PROJECT MANUAL

KALORAMA PARK

TECHNICAL MEMO 1 - SITE INVESTIGATION NOTES

TECHNICAL MEMO 2 - RECOMMENDATIONS

A. Site Plan

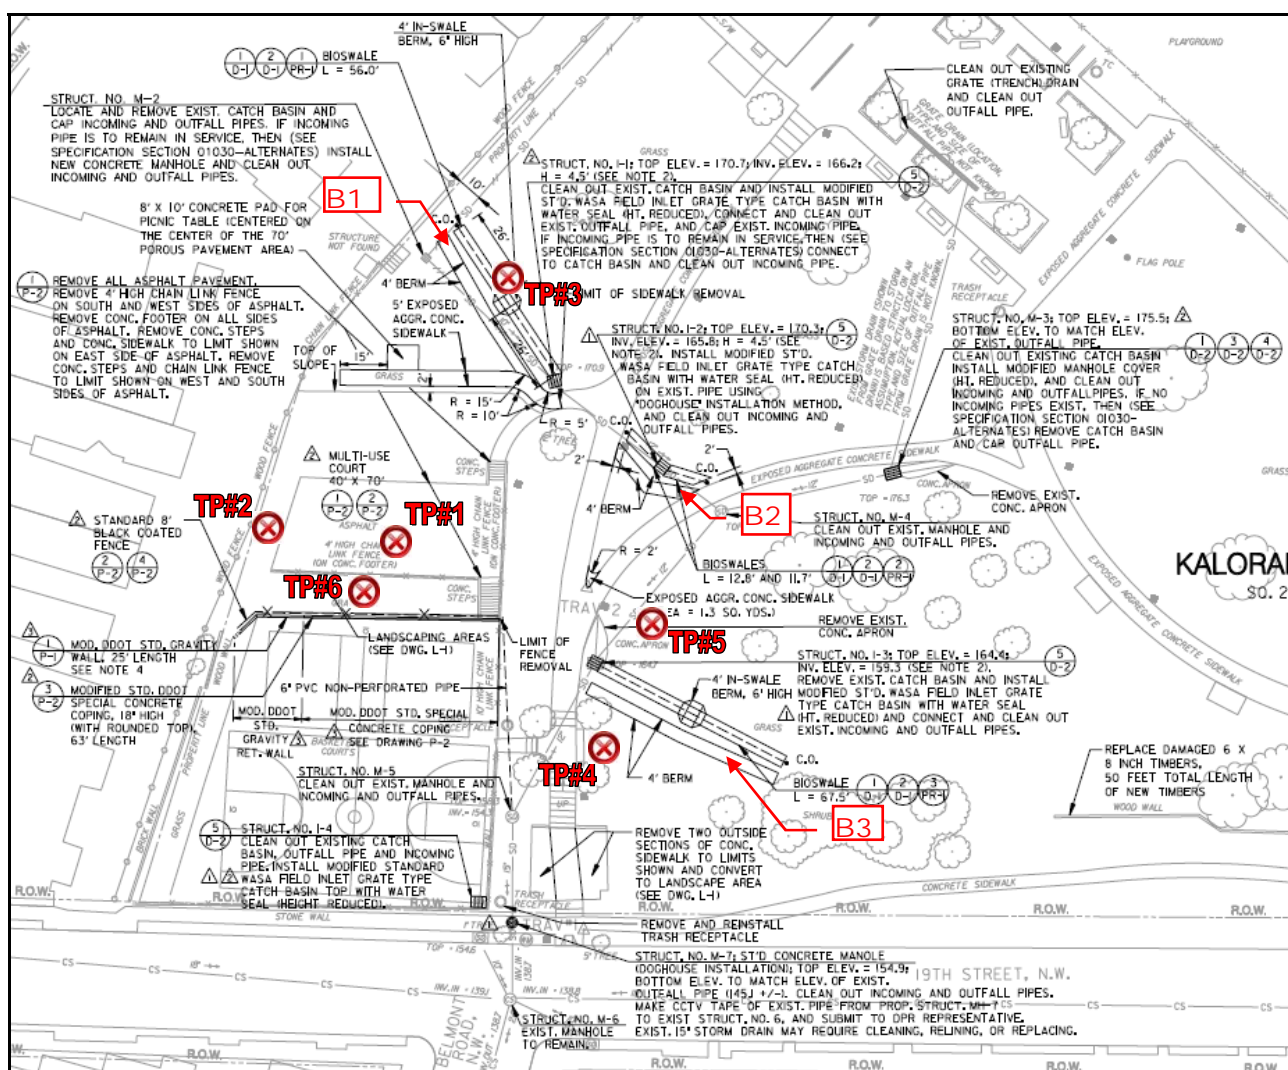
We also conducted a visual evaluation of the berms (B1, B2, and B3), planting beds, and other constructed elements. Our investigation of the site revealed that various elements of the proposed improvements were not properly constructed. The following are our findings and recommendations.

The location for the test pits were determined based on observations during renovation of the park. It is believed that construction procedures used did not comply with the construction drawings, which resulted in construction debris being buried under the lawn areas.

Berm B2

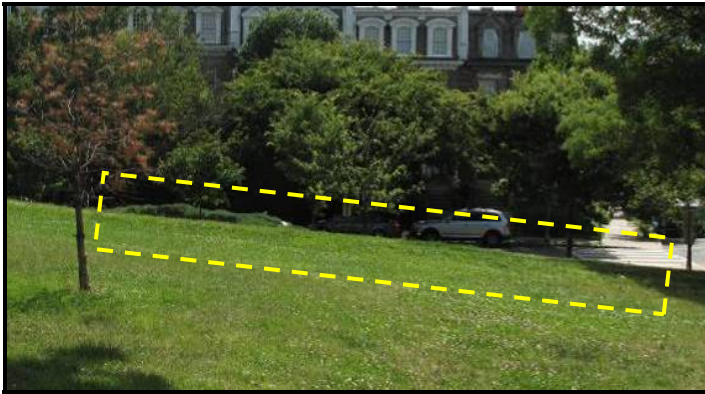
<i>OBSERVATION</i>	<i>INITIAL RECOMMENDATIONS</i>
<ul style="list-style-type: none"> • Bioswale appears to be working normally. • Berm is mostly well covered with lawn. In some area, bare patches appear. • Catch basin at the end of bioswale is dry. 	<ul style="list-style-type: none"> a. Treat area with seed or sod. b. Flush catch basin and cleanout pipes.

E. Areas Around Walls And Planters

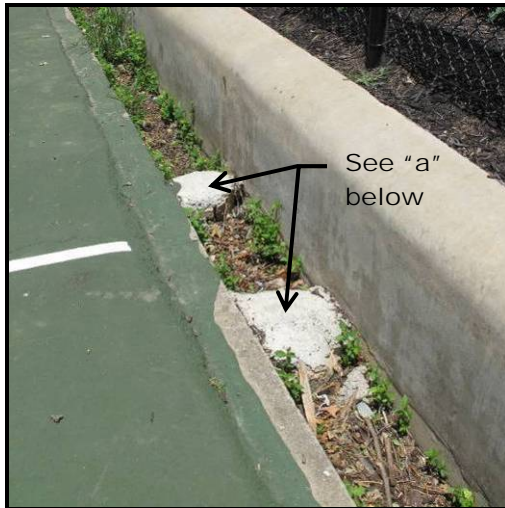
OBSERVATION	INITIAL RECOMMENDATIONS
<ul style="list-style-type: none"> • Pavement between basketball court and retaining wall is missing and hazardous. • Foundation of previously existing basketball court remains in place, and is an obstruction to anyone using the court. 	<ul style="list-style-type: none"> a. Remove top 12" of old basket ball hoop concrete foundation. b. Install basketball court surface with a concrete base at gap between retaining wall and existing court. Provide a continuous expansion joint between wall and subbase.

Terraced Timber Retaining Wall and Planter

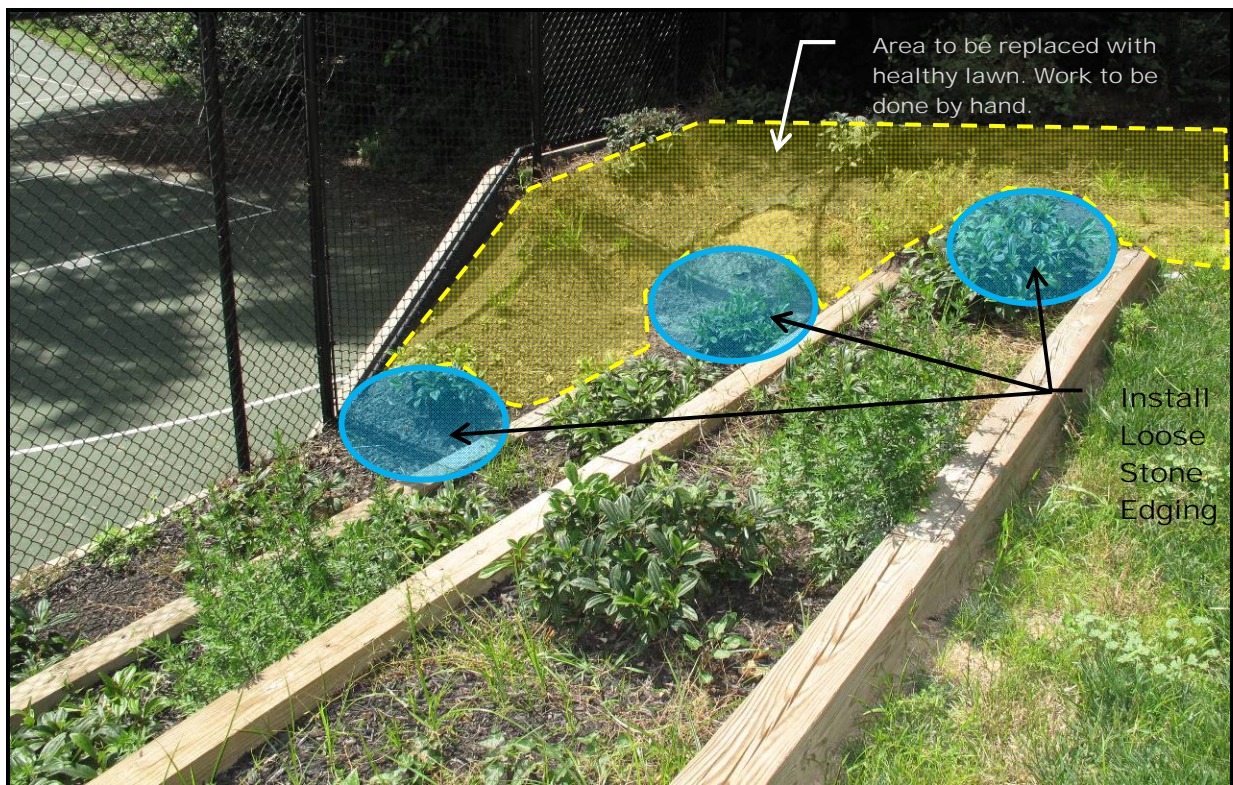
OBSERVATION	INITIAL RECOMMENDATIONS
<ul style="list-style-type: none"> Terraced wall was installed by second contractor without plans. Layout was coordinated with DPR. Terraced planting bed at the north ends is eroding and existing filter fabric is falling apart. 	<p>a. Remove planting and filter fabric at the north end of the terraced planter and replace with sod or seed. Provide $\pm 18''$ dia. rounded loose stone edging between grass and planter to separate lawn from planting (see images above). There should be no digging past 12".</p>

Task 3: Recommendations for Improvements

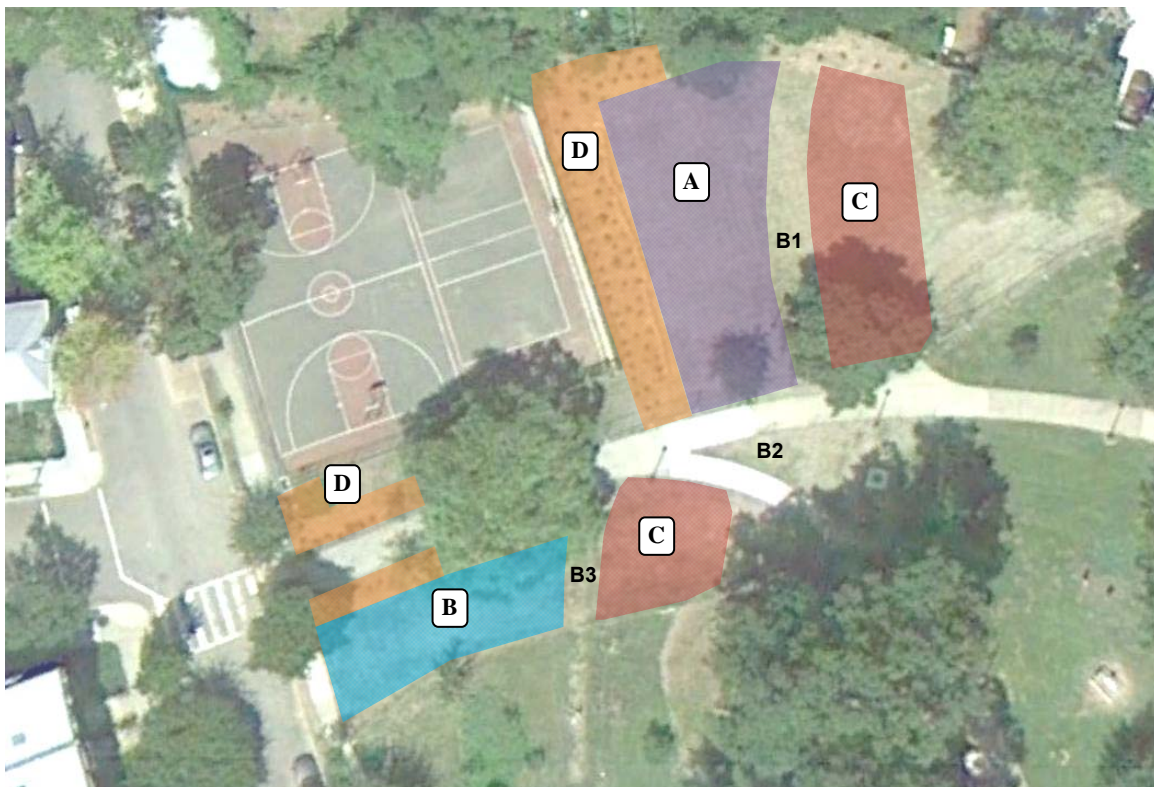
This plan represents the site improvement zones and berms, which are describe in this technical memo. This information will be used to develop biddable plans and specifications for improvements to Kalorama Park.
